#### **Addendum 47 – UN Regulation No. 48**

#### **Revision 14 - Amendment 3**

Supplement 3 to the 08 series of amendments – Date of entry into force: 24 September 2023

#### **Uniform provisions concerning the approval of vehicles with regard to the installation of lighting and light-signalling devices**

Model A

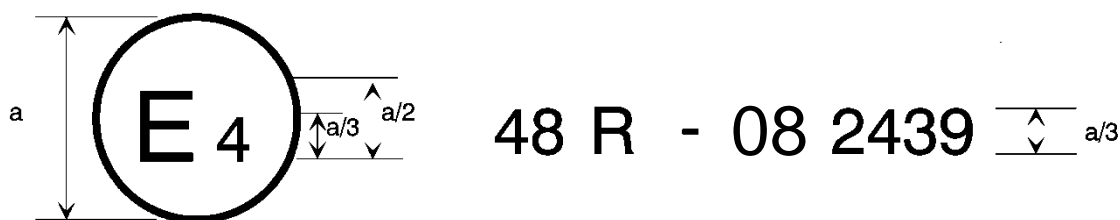
Annex 2, amend to read:

a = 8 mm min.

The above approval mark affixed to a vehicle shows that the vehicle type concerned has, with regard to the installation of lighting and light-signalling devices, been approved in the Netherlands (E4) pursuant to UN Regulation No. 48 as amended by the 08 series of amendments. The approval number indicates that the approval was granted in accordance with the requirements of UN Regulation No. 48 as amended by the 08 series of amendments.
